Materials Recovery Facility
Safety Observation Form

Date: Tuesday, July 5th, 2016

Name of Observer: Shawn Qualls

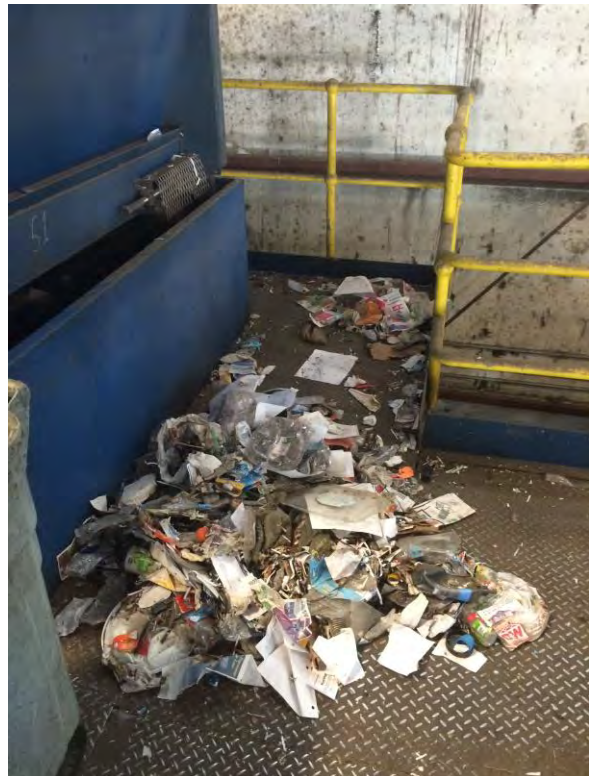
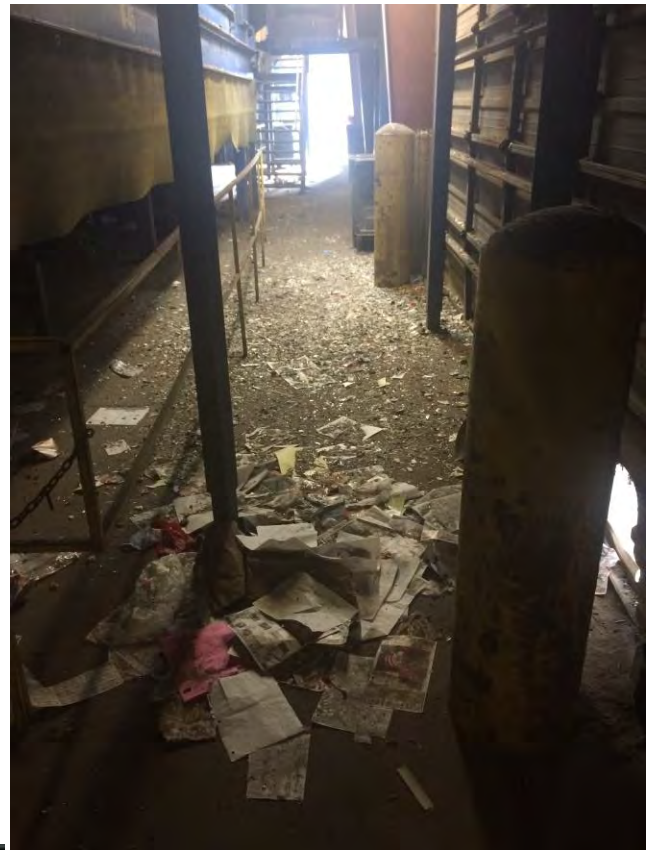
Machine not locked out. (May fall under minor service exception? [1910.147(a)(2)(ii)])

Lots of uncapped wires, potential shock hazard. (work in progress)

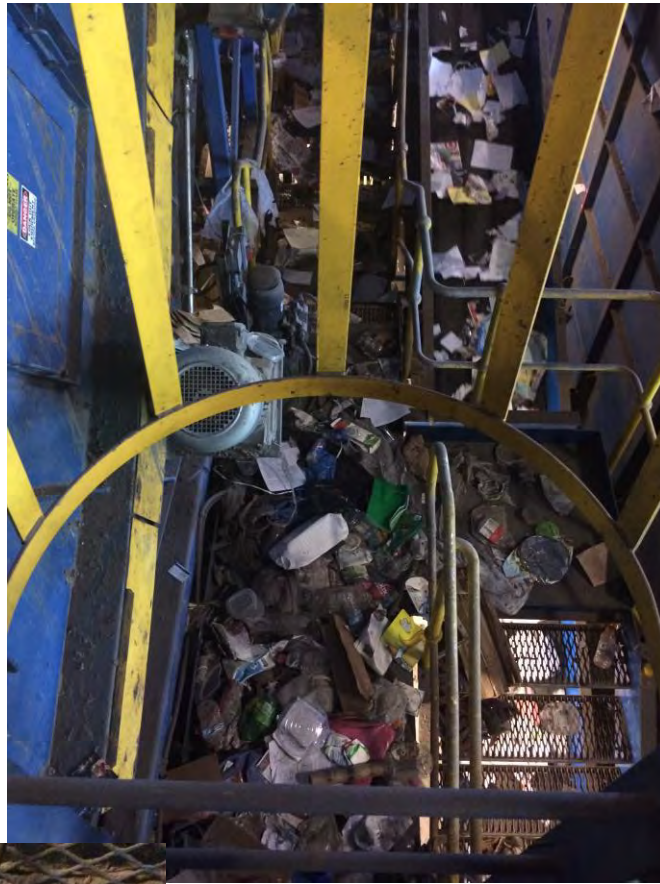
Top left: Possible clearance issue.

Top right: Fire extinguisher still missing

Bottom: Replace missing eye wash bottle

All: Housekeeping – obstructed walkways and stairways [1910.22(a)(1)]

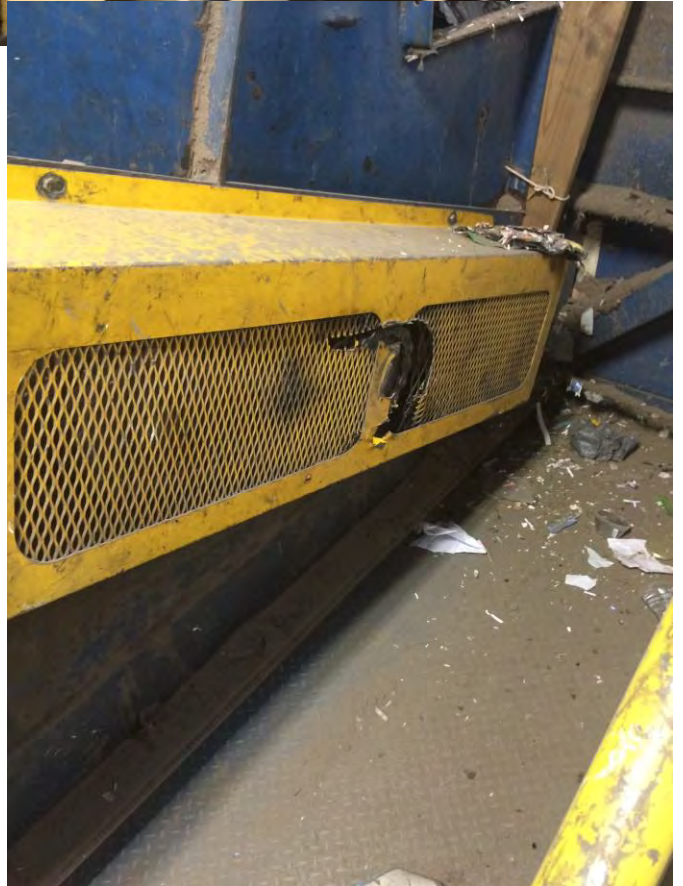
Bottom left: possible clearance issue?

Top: Obstructed aisleways

Bottom: PPE left lying around

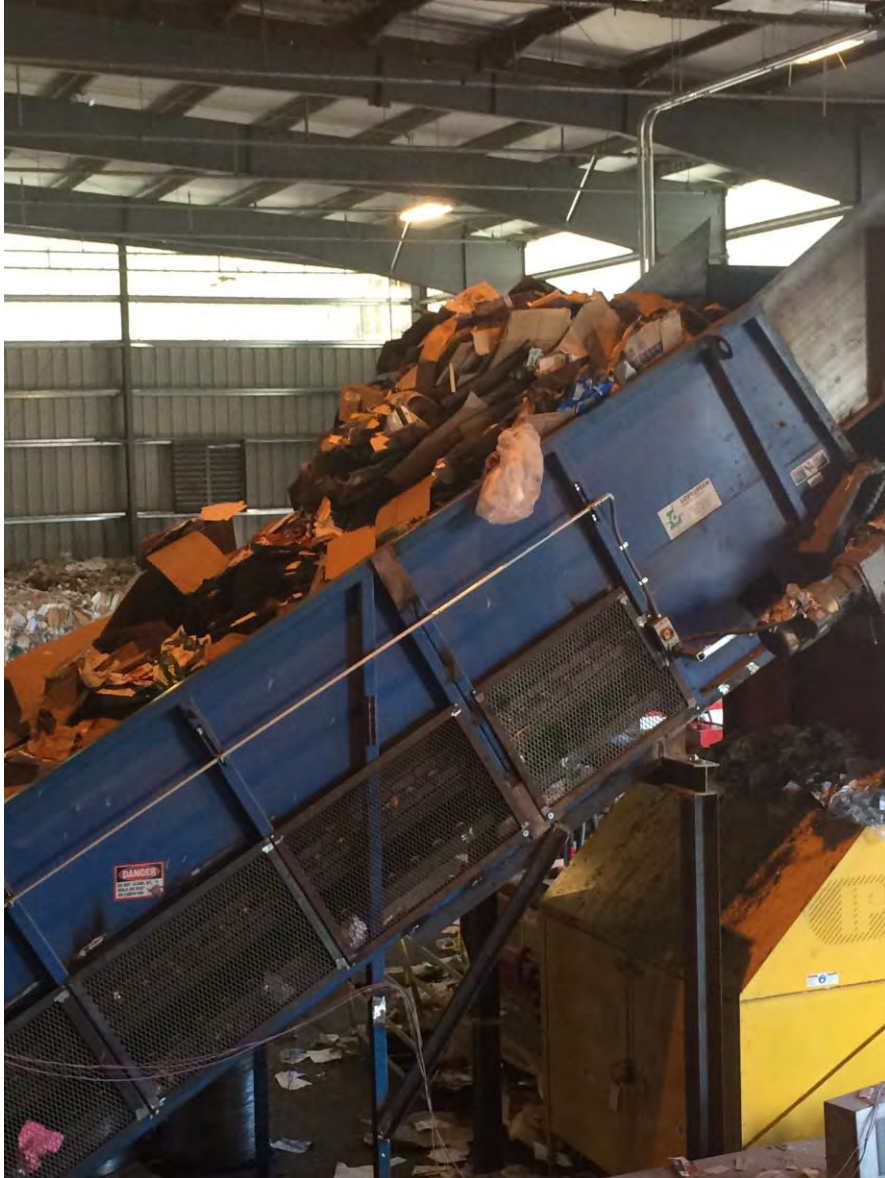
Top left: Looks like the upper motor is missing a guard

Top right: Center motor – guard (top) is not secured to motor.

Bottom left: Panel not secured

Bottom right: Damaged guard

Conveyor overloaded
